PUBLIC UTILITIES COMMISSION

RE: Sanger Substation Expansion Project—Review of Minor Project Refinement #1 Request

Exhibit 1: MPR #1 Map

Exhibit 1: MPR #1 Map

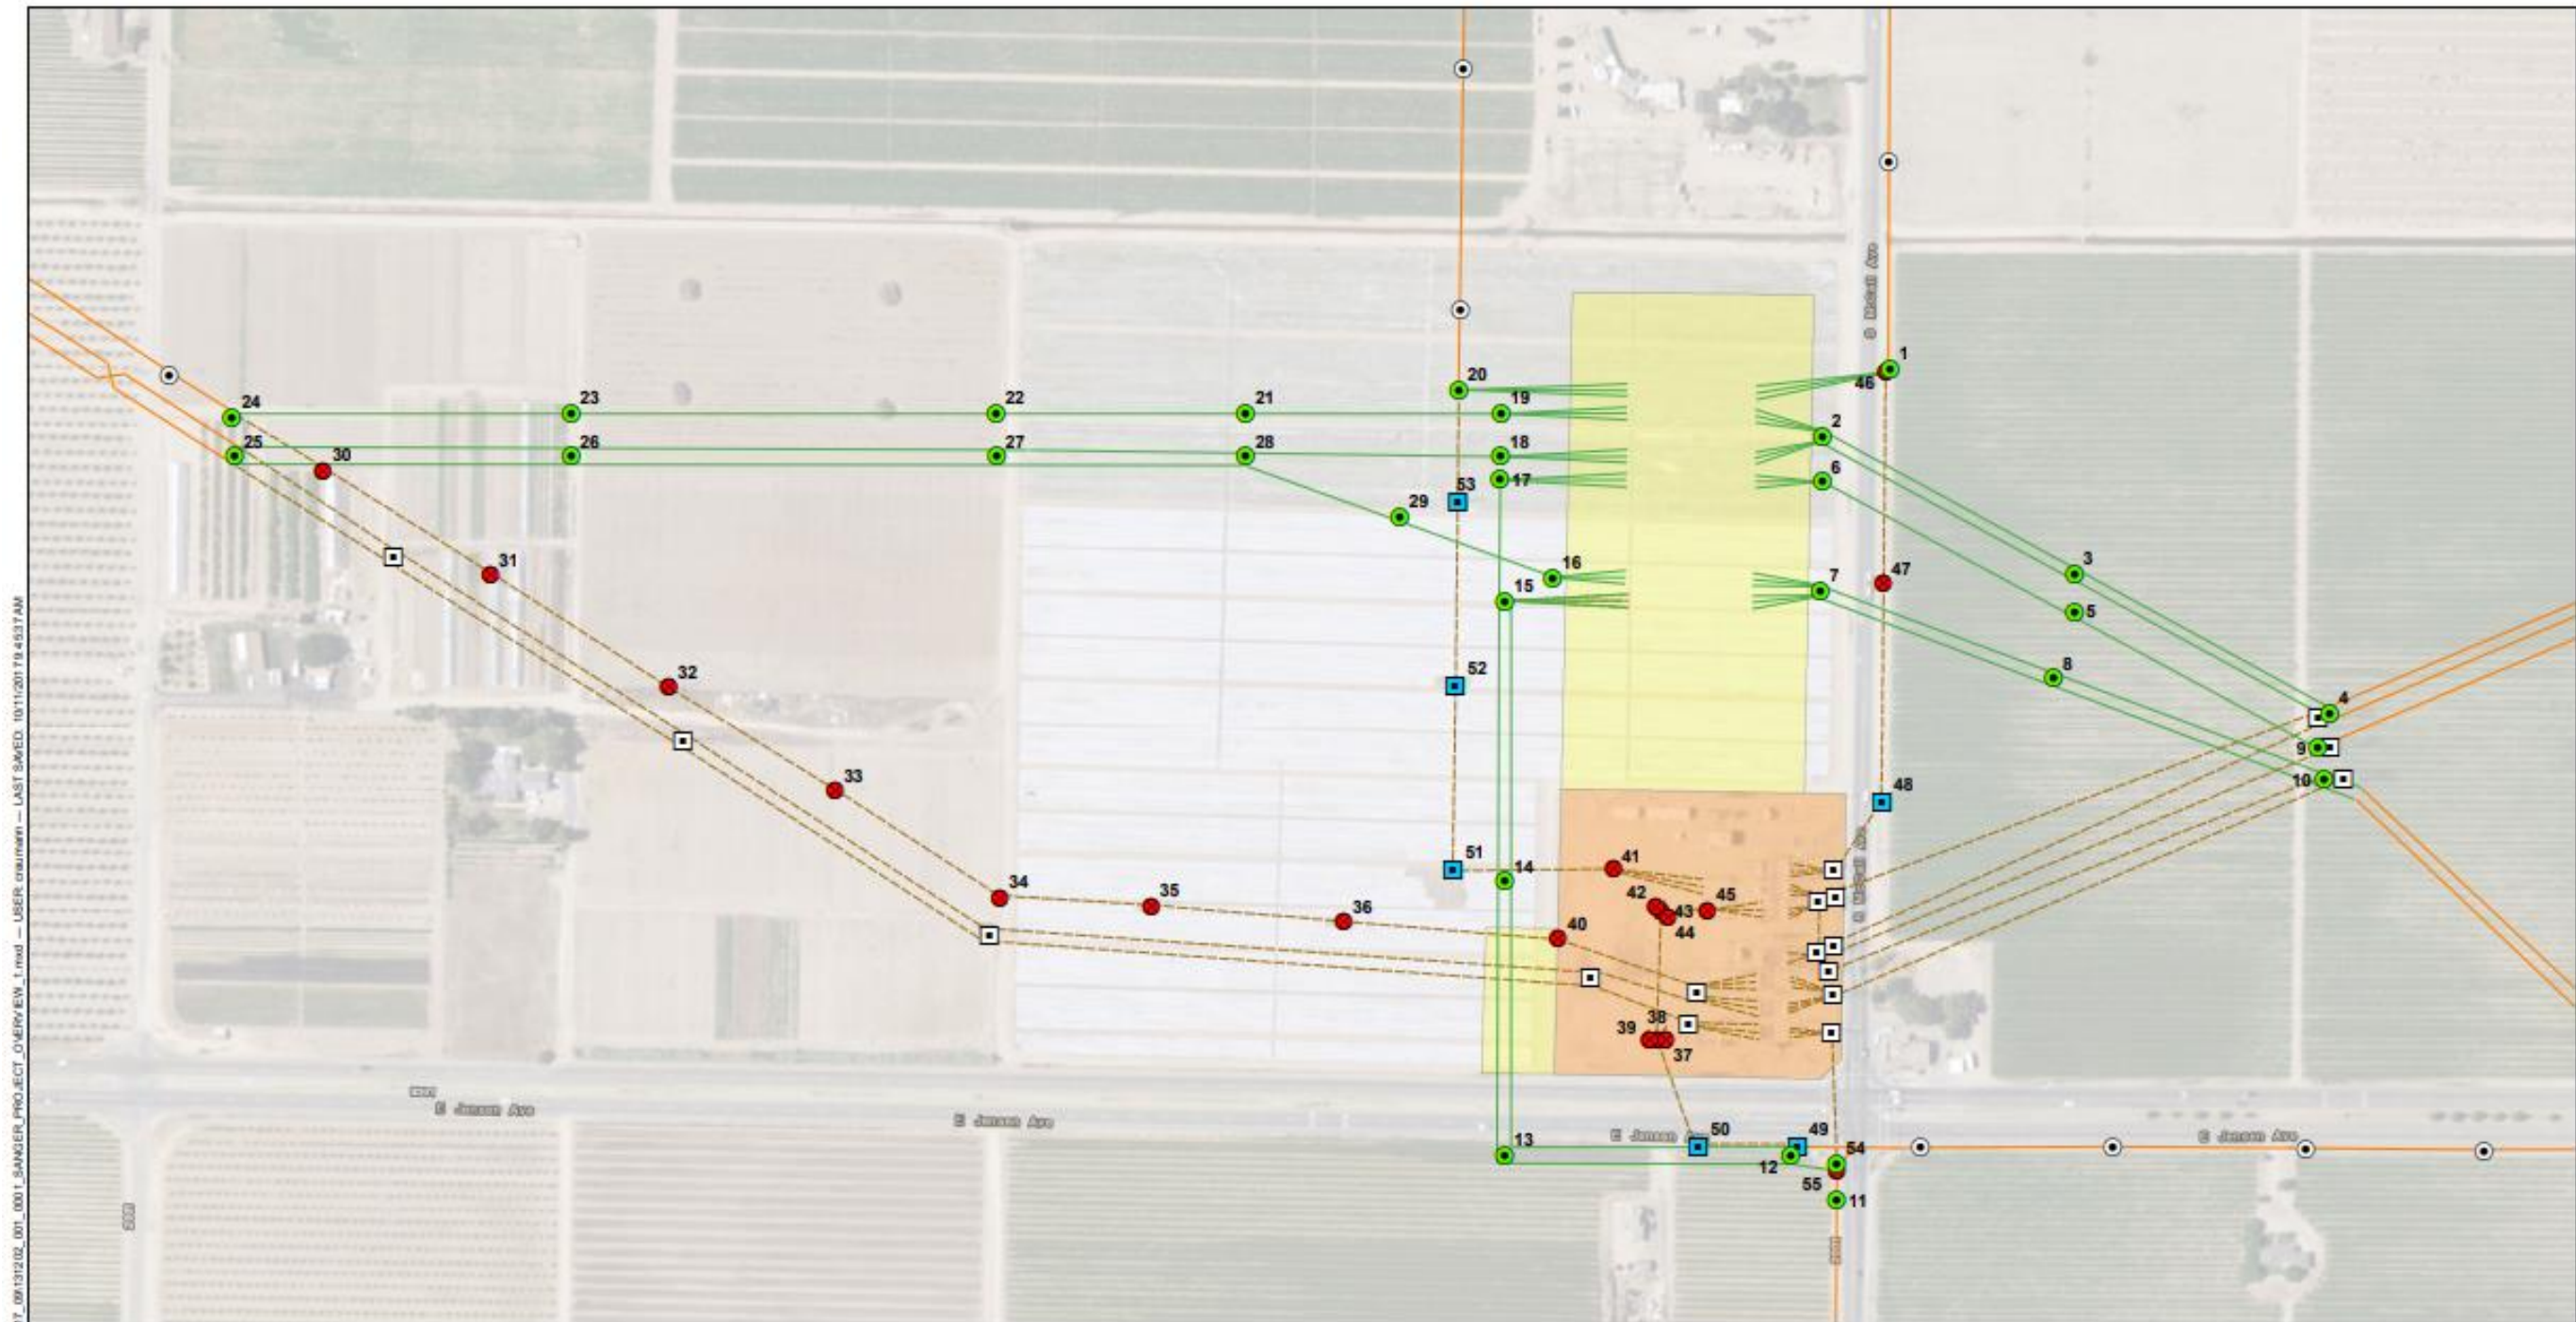
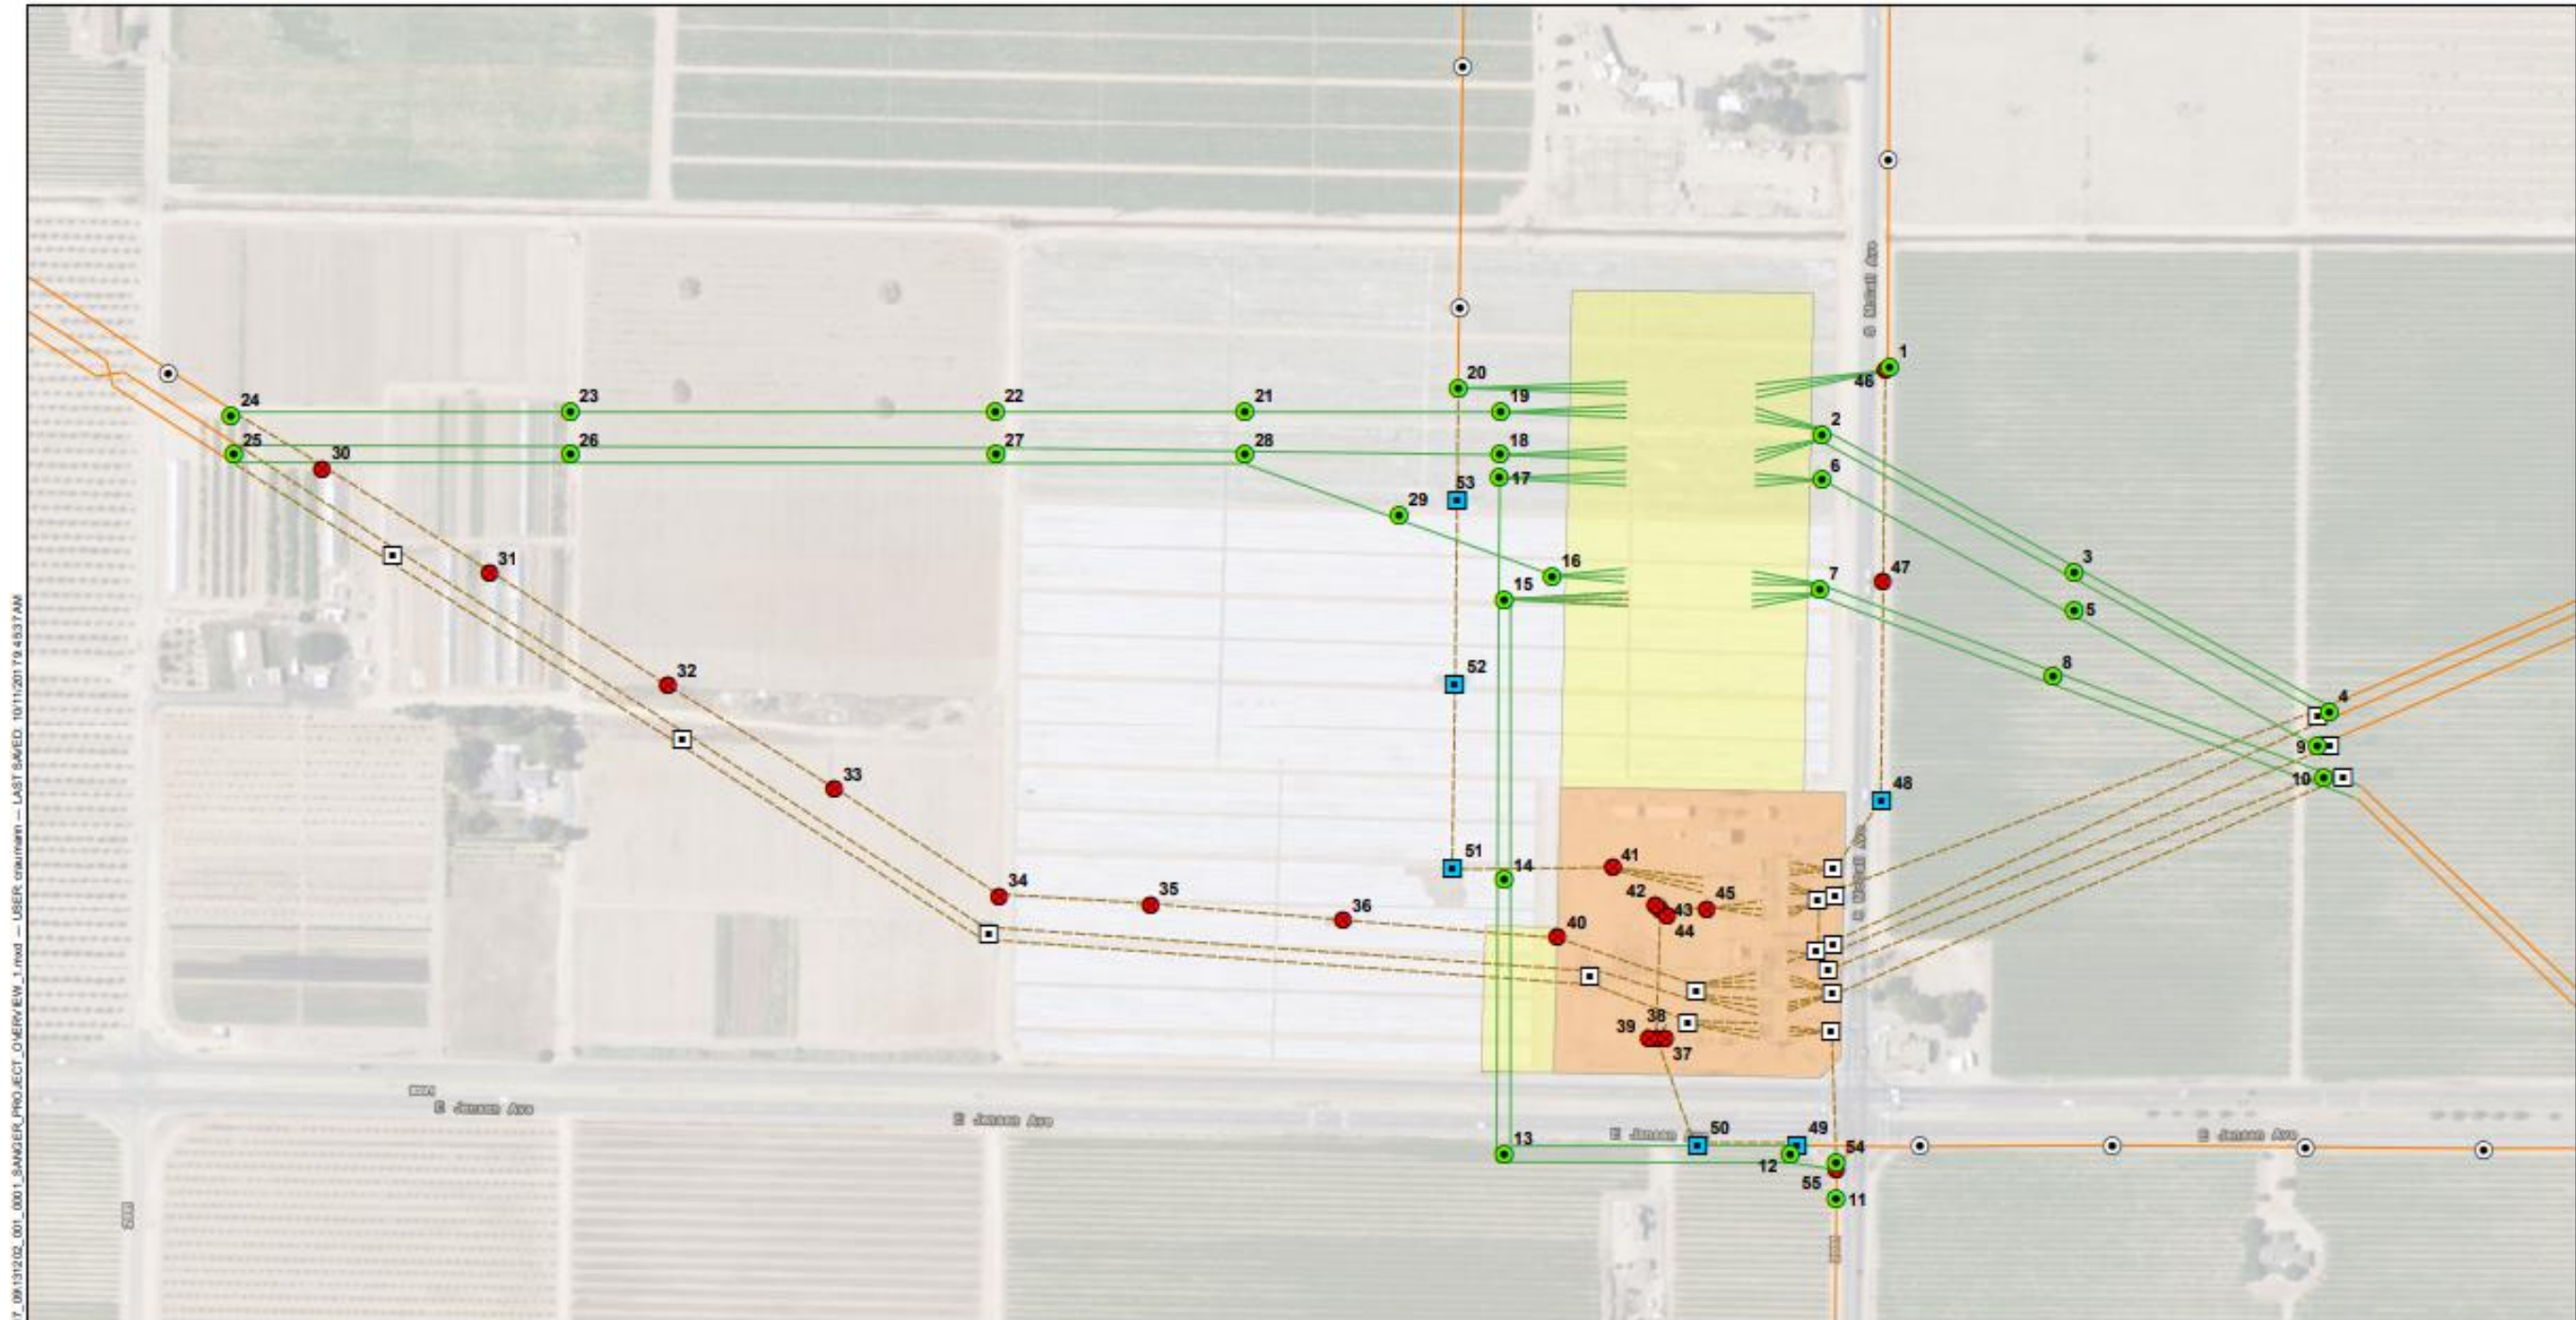
The “power line reconfiguration” component of the project design, as discussed in the MND (March 2017), includes replacing 18 wood poles and 17 Lattice Steel Towers (LSTs) with 29 Tubular Steel Poles (TSPs). The final design now proposed is to replace 18 wood poles and 17 LSTs with 28 TSPs and 2 wood poles.

In addition, after further refinement of engineering design, two new wood poles (instead of the previously proposed TSPs) will replace one existing LDSP pole south of the substation. PG&E is proposing to use wood poles instead of TSPs because an existing gas line was discovered in the area, and the wood poles would avoid any arc-flash hazards. The locations of four other TSPs have also been adjusted as described below. These changes are shown in the attached and revised figures accompanying this summary. Specifically, they include:

- Pole #11– A TSP was previously proposed in this location immediately south of E. Jensen Avenue near the southeast corner of the substation. During final design, it was determined that the proposed TSP would need to be replaced with a new wood pole and the location offset from the previous location slightly by 8 feet north and 8 feet east. This new wood pole will require two guy lines and one anchor. The pole type and location was changed due to the presence of an existing gas line.

- Pole #54 – During final design, it was determined that a new wood pole rather than a TSP would be required in this location due to the presence of the existing gas line.

- Pole #55 – The existing LDSP in this location would be removed and the new wood pole (pole #54) would be placed 10’ north of the existing pole #55.
- Pole #1 – The location of this new TSP, near the northeast corner of the planned substation expansion footprint and east of S. McCall Avenue, would move approximately 8’ south of the previous location. This pole was shifted away from S. McCall Avenue due to new restrictions on clearances from Fresno County.

- Pole #10 – This pole is located in an agricultural field approximately 750’ east of the existing substation. The location of this pole is proposed to be moved approximately 14’ south and 15’ west of its previous location. The decision to move Pole #10 was done to move further away from the existing tower near this location to avoid the tower foundation during construction. A new location was proposed out of the agricultural field and closer to the access road for ease of construction.

- Pole #8 – This proposed TSP, located west of S. McCall Avenue, would move approximately 2’ north and 31’ west from its previous location. Due to the change in location of Pole #10, pole #8 had to be moved to accommodate the new angle of the line.

- Pole #24 – Pole 24 is located approximately 2,100 feet to the west of the substation, just east of S. Thompson Avenue. As compared to its previous location, this pole would move approximately 8’ to the south to relocate it out of the existing farm access road.
